1978 Corvette: Service Bulletin: Removable Roof Panel Fit

Subject: Removable Roof Panel Fit
Model and Year: 1978 Corvette
Source: Chevrolet Dealer Service Technical Bulletin
Bulletin No: 78-T-23
Section: I
Date: April, 1978

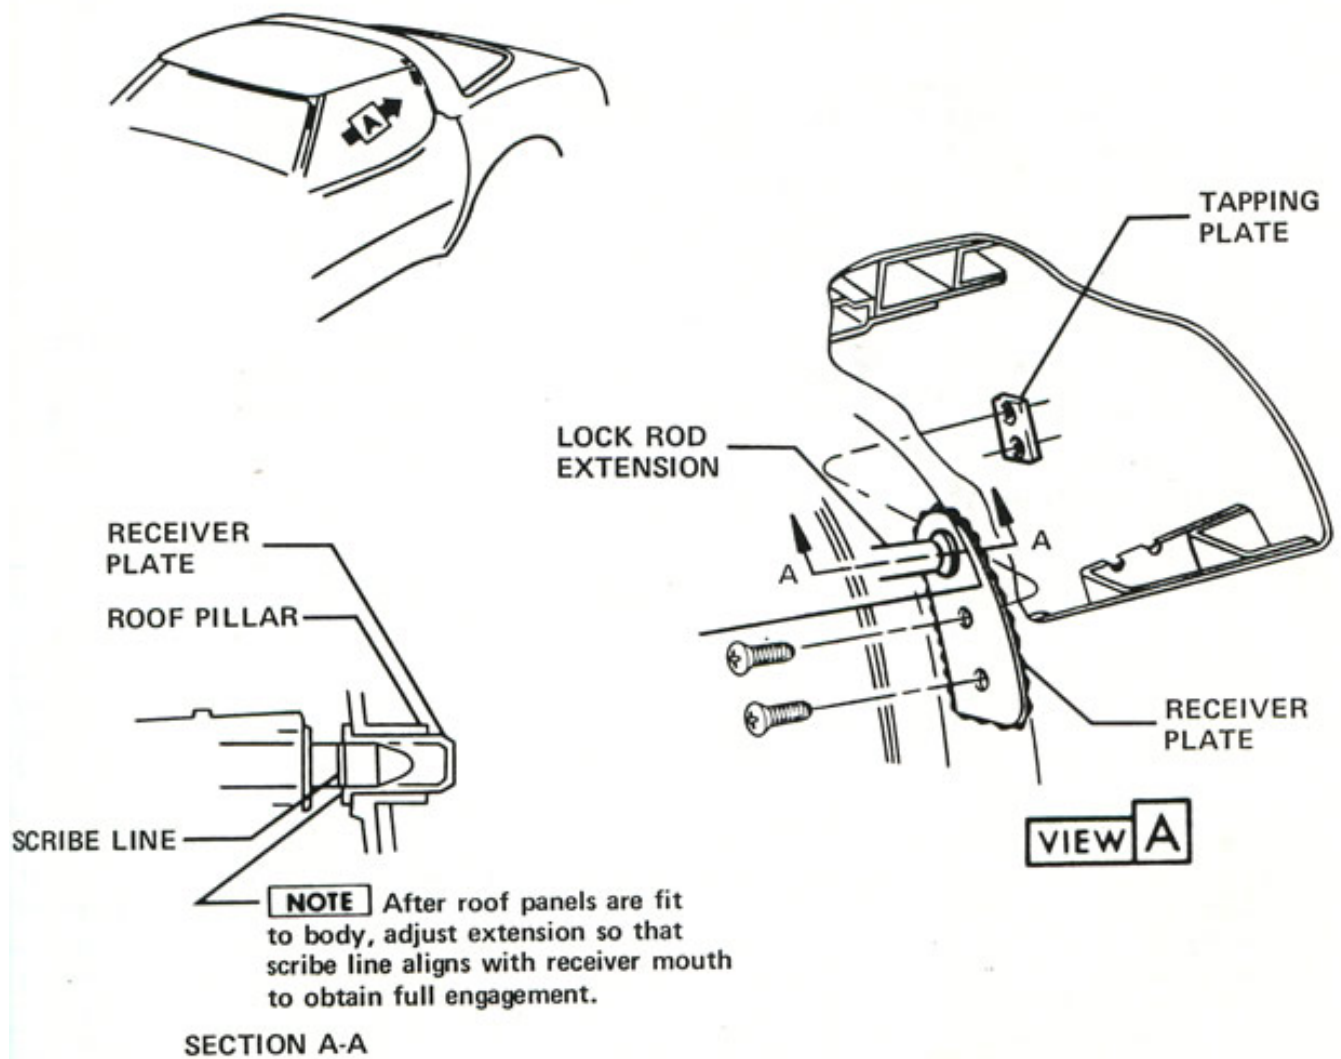
Some early 1978 Corvette removable roof panels may be bowed in relation to the windshield header and/or rear roof. This condition can be caused by an improperly positioned roof lock receiver plate.

1. Remove the rear roof corner garnish and lower roof trim panel. NOTE: It is not necessary to remove the shoulder belt or retractor.
2. Remove the roof lock receiver plate screws. Hold the tapping plate, located behind the roof pillar, to prevent it from falling (see illustration on page 2). Remove any excess sealer from pillar and receiver plate.

3. Using a small round file, elongate (lower) the three holes in the roof pillar as required to obtain a relaxed roof panel with a flush fit. This will be a trial and error process of installing the receiver plate and checking that the roof panel lock rod extension engages easily.

4. When an acceptable roof panel fit is achieved, thoroughly pack the area behind the receiver plate with 3M Strip-calk or equivalent.
5. Reinstall interior trim panels.
